TELEVISION SERVICE TIPS

SERVICE DATA - Chassis CTC16X 1965 No. T6

The PW700 Solid Copper Circuit Component Assembly Board on page 34, 1965 No. T6, shows a seven pin tube instead of a nine pin tube for V702. The correct phantom view of PW700 is shown below.

COLOR AFPC ALIGNMENT
(SHOP PROCEDURE)

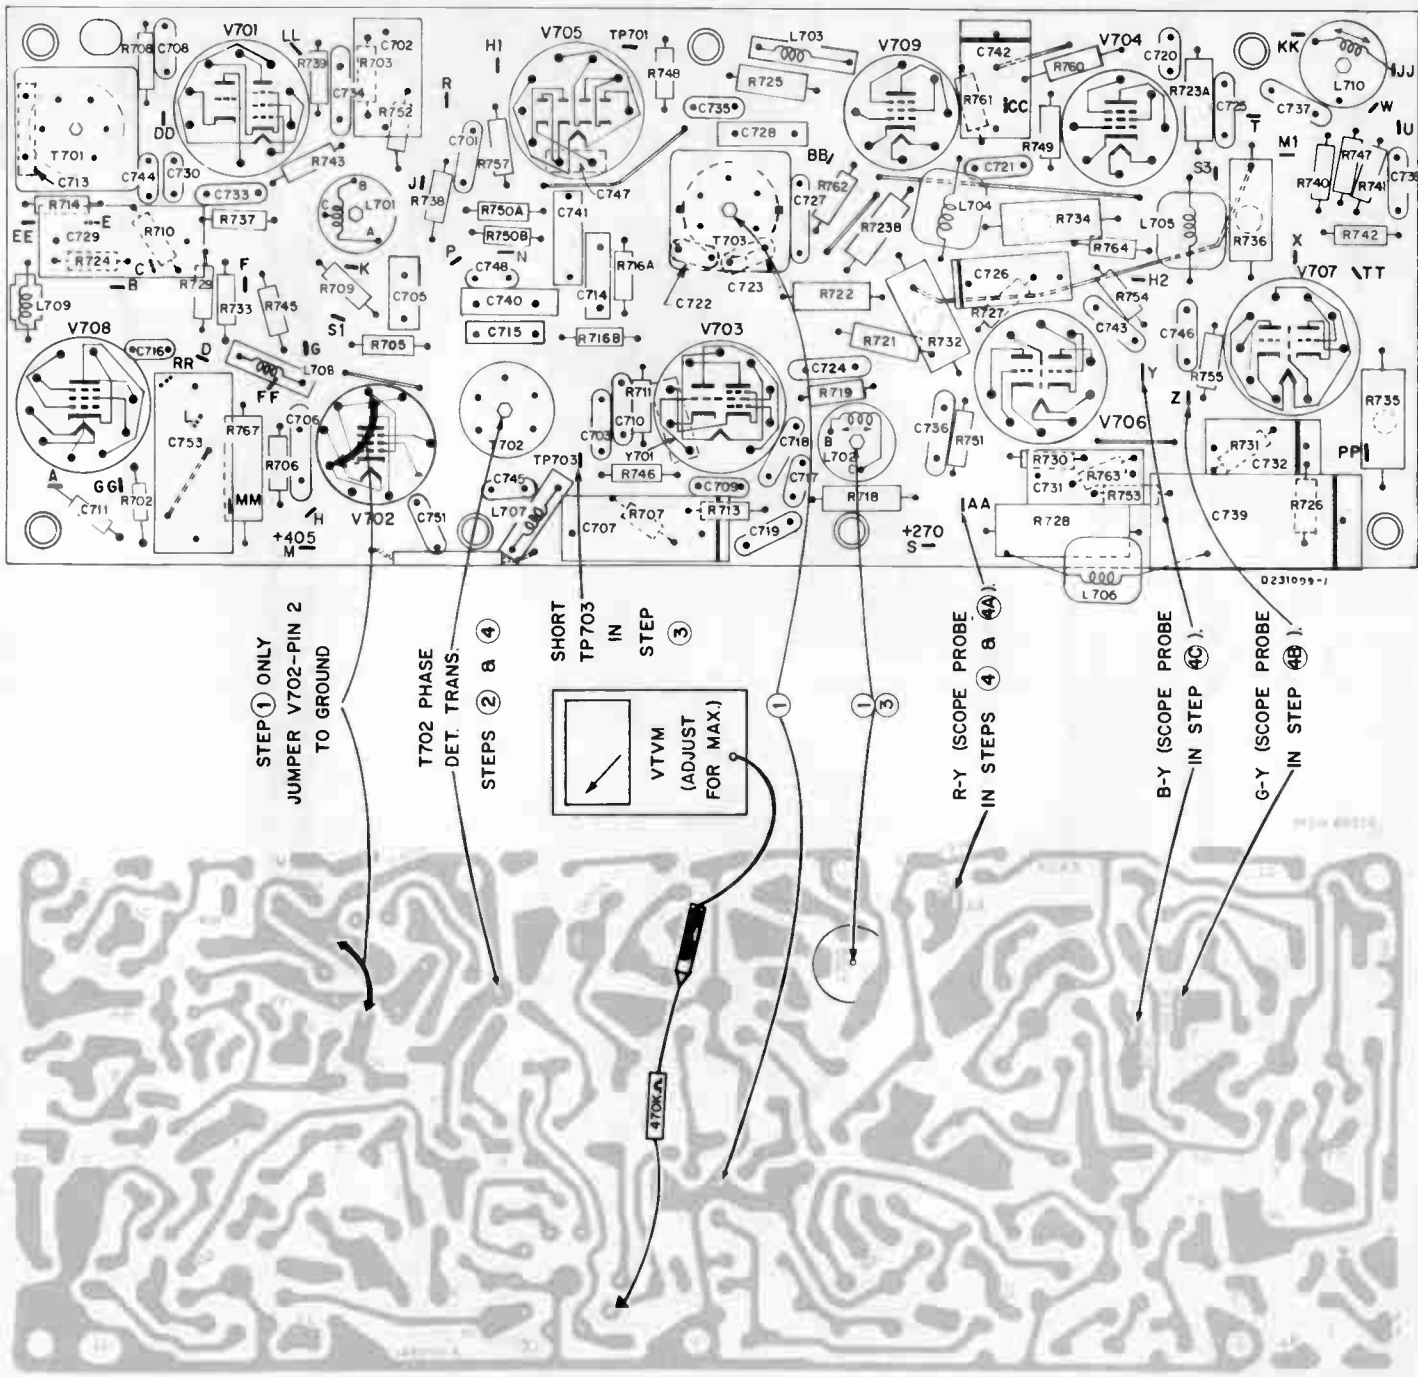
The shop procedure for color AFPC Alignment on page 23 should also have a 9 pin tube as V702. In Step ① pin 2 should be grounded. The corrected drawing is shown on the back of this page.

In the alignment chart on page 22, the instruction in Step 1 pin 2 of V702 should be grounded as shown below.

ALIGNMENT PROCEDURE		
STEP	ADJUST	REMARKS
1	Peak 3.58 mc. oscillator transformer (Jumper V702-2 to ground)	T703 (bottom) Adjust T703 for maximum DC reading on the V.T.V.M. If the 3.58 mc. oscillator is not running, no reading will be obtained. If necessary, adjust the reactance tube plate coil L702 to start the oscillator. After adjustment is made, remove jumper from V702—Pin 2.

STEP ① ONLY
JUMPER V702-PIN 2
TO GROUND

PW700 Solid Copper Circuit Assembly for Chassis CTC17X (Chroma)

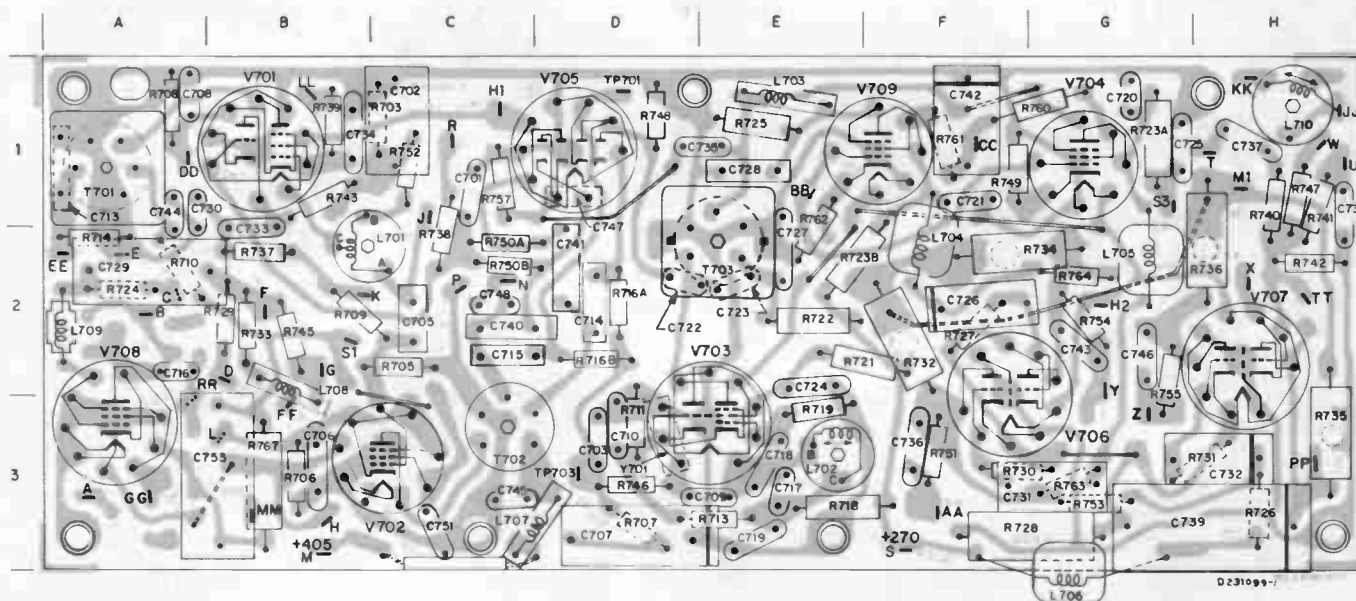
The PW700 Solid Copper Circuit Component Assembly on page 34, 1965 No. T12, shows a seven pin tube instead of a nine pin tube for V702. The correct phantom view of PW700 is shown below.

COLOR AFC ALIGNMENT
(SHOP PROCEDURE)

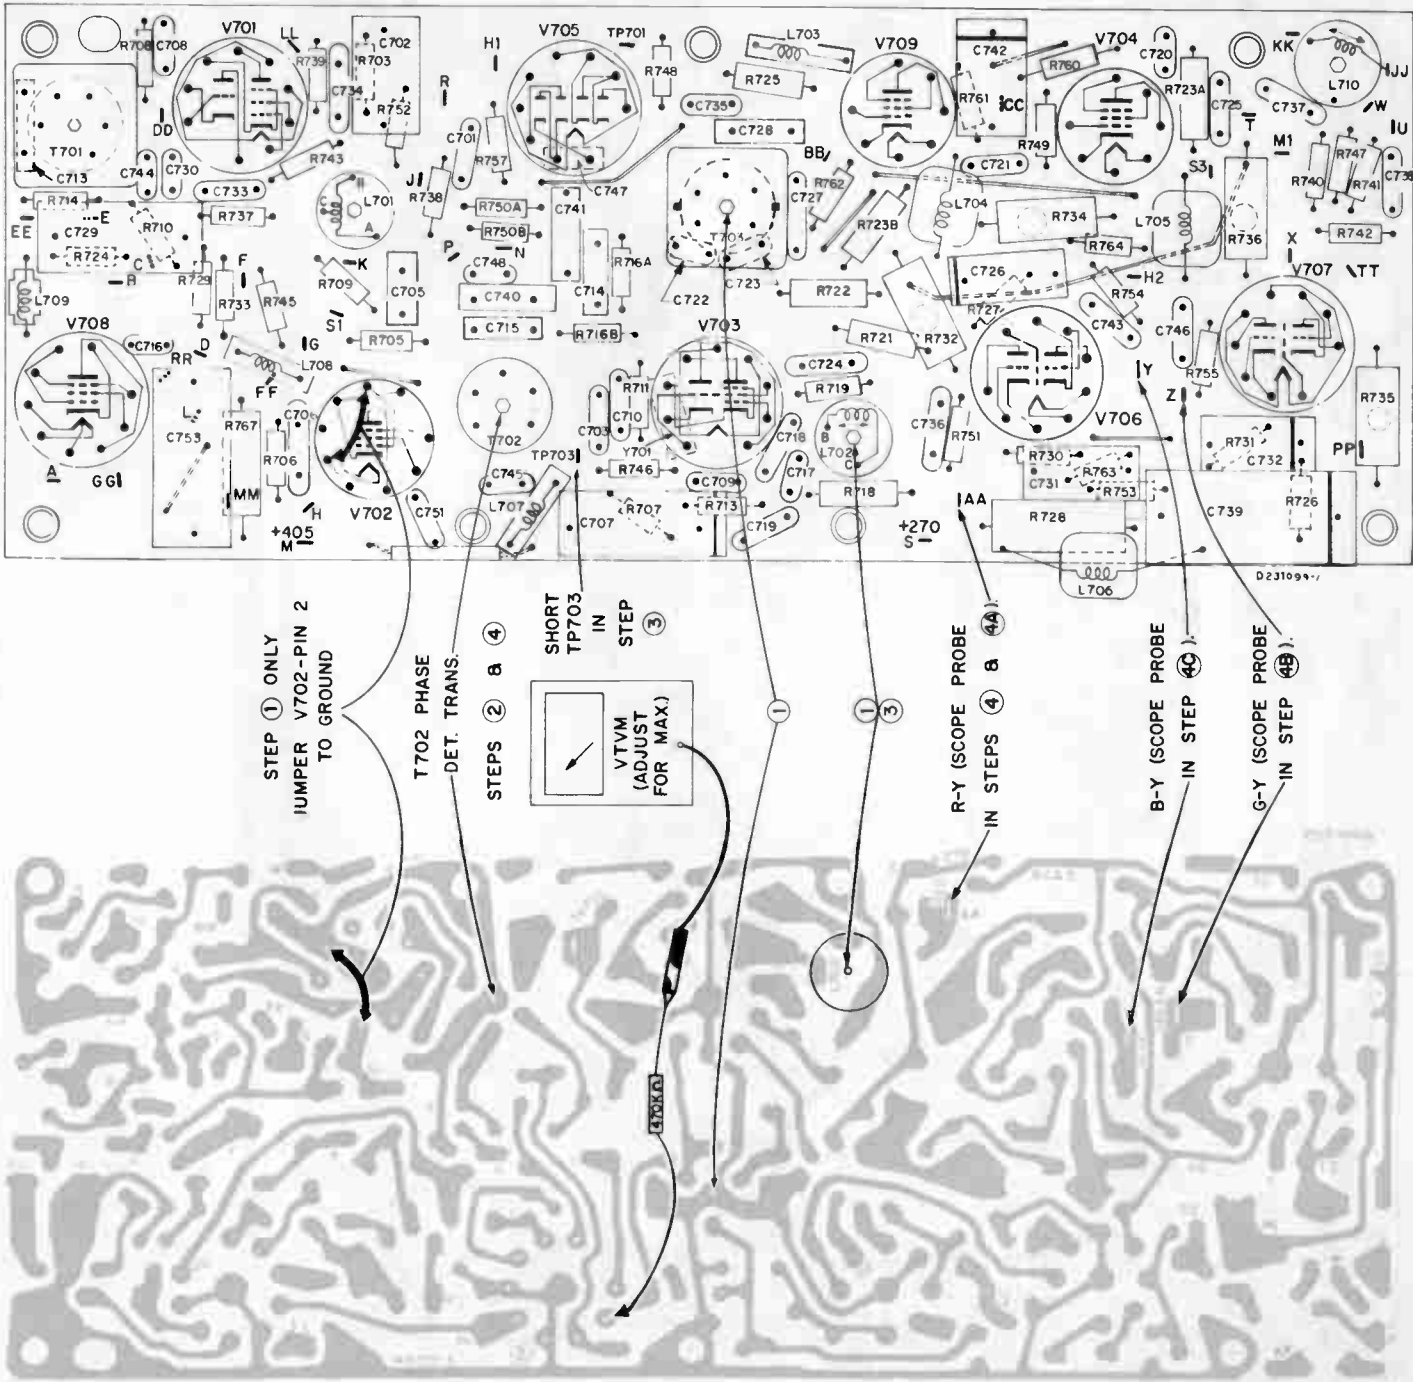
The shop procedure for color AFPC Alignment on page 23 should also have a 9 pin tube as V702. In Step ① pin 2 should be grounded. The corrected drawing is shown on the back of this page.

In the alignment chart on page 22, the instruction in Step 1 pin 2 of V702 should be grounded as shown below.

ALIGNMENT PROCEDURE			
STEP	ADJUST	REMARKS	
1	Peak 3.58 mc. oscillator transformer (Jumper V702-2 to ground)	T703 (bottom)	Adjust T703 for maximum DC reading on the V.T.V.M. If the 3.58 mc. oscillator is not running, no reading will be obtained. If necessary, adjust the reactance tube plate coil L702 to start the oscillator. After adjustment is made, remove jumper from V702—Pin 2.

STEP ① ONLY
JUMPER V702-PIN 2
TO GROUND
